2018/6349/P & 2019/0421/L – 19 Well Road

Delegated Report		Analysis sheet		Expiry Date:		15/02/2019	
(Members Briefing)		N/A / attached		Consultation Expiry Date:		20/12/2019	
Officer				Application Number(s)			
Kate Henry				1) 2018/6349/P 2) 2019/0421/L			
Application Address				Drawing Numbers			
19 Well Road London NW3 1LH				Please refer to draft decision notice			
PO 3/4		Area Team Signature		C&UD		Authorised Officer Signature	
Proposal(s)							
1) Extension to existing basement under front garden, including 2x lightwells 2) Extension to existing basement under front garden, including 2x lightwells; associated internal alterations							
Recommendation(s):		1) Grant conditional planning permission subject to section 106 legal agreement 2) Grant conditional listed building consent					
Application Type:		1) Full Planning Permission 2) Listed building consent

Proposal: Extension to existing basement under front garden, including 2x lightwells

View of arched entrance from within application site

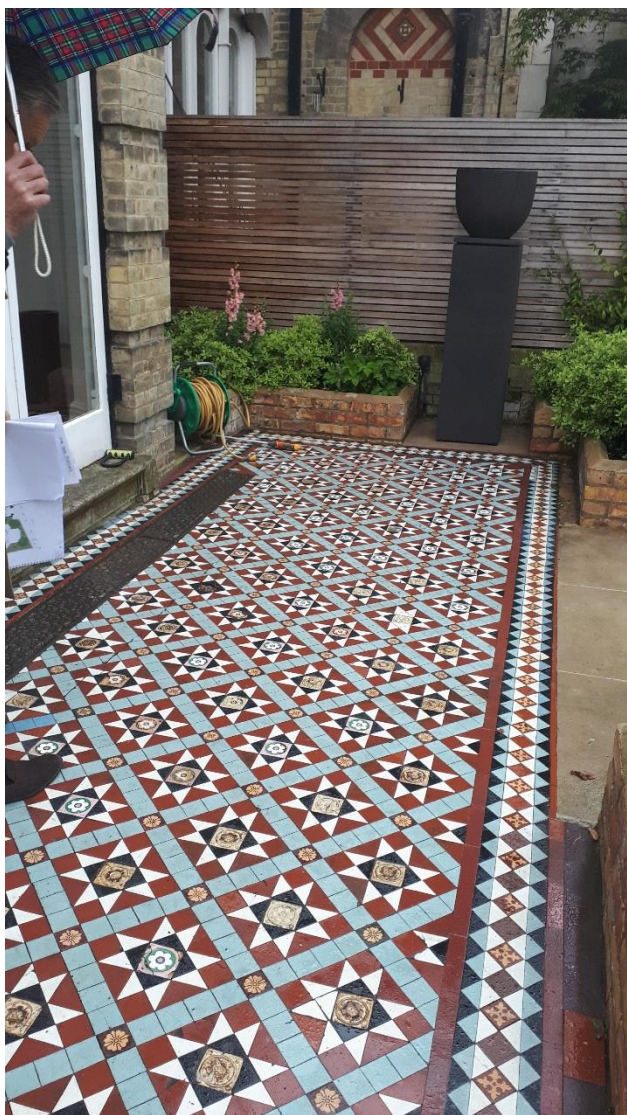
- 4.23. There is also concern that the proposed works could cause harm to the decorative archway and attached wall to the south of the host building (see picture below). On request, details have been provided relating to the proposed monitoring of the historic archway and attached wall during construction works. A suitable condition is suggested to require full details of the number, size, position, method of fixing, remediation and time period for the monitoring, prior to the commencement of development, to ensure it is carried out in a satisfactory manner.

- 7 No demolition or development shall commence until full details of the monitoring and recording of the listed building, decorative entrance and attached wall have been submitted to and approved in writing by the local planning authority. Such details shall include the number, size, position, method of fixing and necessary remediation works of the necessary equipment, and proposed timescales. The relevant part of the works shall not be carried out otherwise than in accordance with the details thus approved.

View of tiles on patio

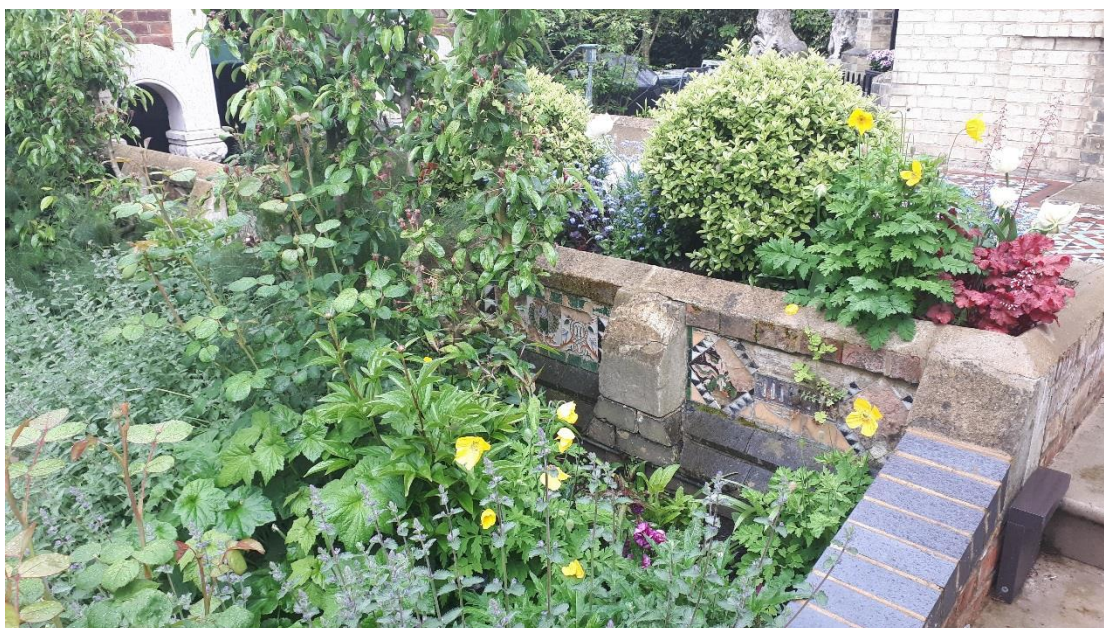
4.21. There are encaustic and geometric floor tiles at the rear of the property on the patio which are considered to be of historic interest and which could be damaged by the proposed works (see picture below). On request, a method statement has been provided to detail the proposed recording, cataloguing, lifting and subsequent relaying of the tiles. A suitable planning condition is suggested to require that the proposed works accord with the methods outlined in the statement, and that all tiles are re-used, unless otherwise agreed in writing with the local planning authority.

- 5 The works hereby approved shall be carried out in accordance with the methods outlined in the submitted 'Method Statement: Recording, Cataloguing, Lifting and Subsequent Relaying of Encaustic and Geometric Floor Tiles (dated 16 May 2019)' and subsequent email from Ted Walters dated 15/02/2020, and all the tiles shall be re-used, unless otherwise agreed in writing with the Local Planning Authority.

View of historic retaining walls

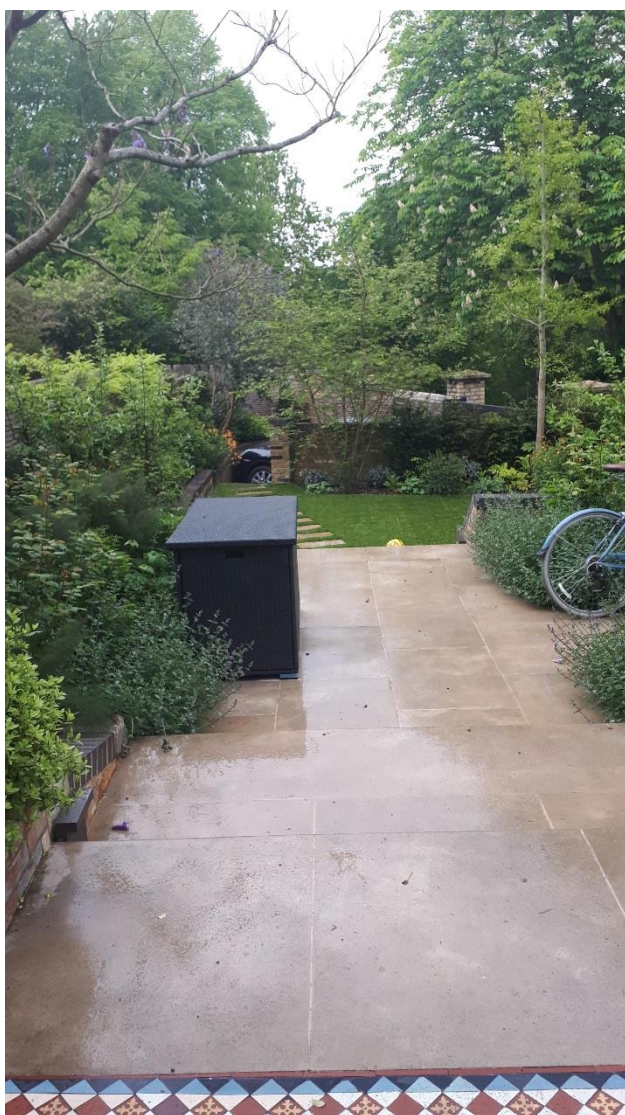
- 4.22. On request a method statement has also been provided to detail the proposed recording and protection of historic masonry, including the ceramic features in the retaining walls in the front garden (see picture below). A suitable planning condition is suggested to require that the proposed works accord with the methods outlined in the statement, and that all materials are re-used, unless otherwise agreed in writing with the local planning authority.
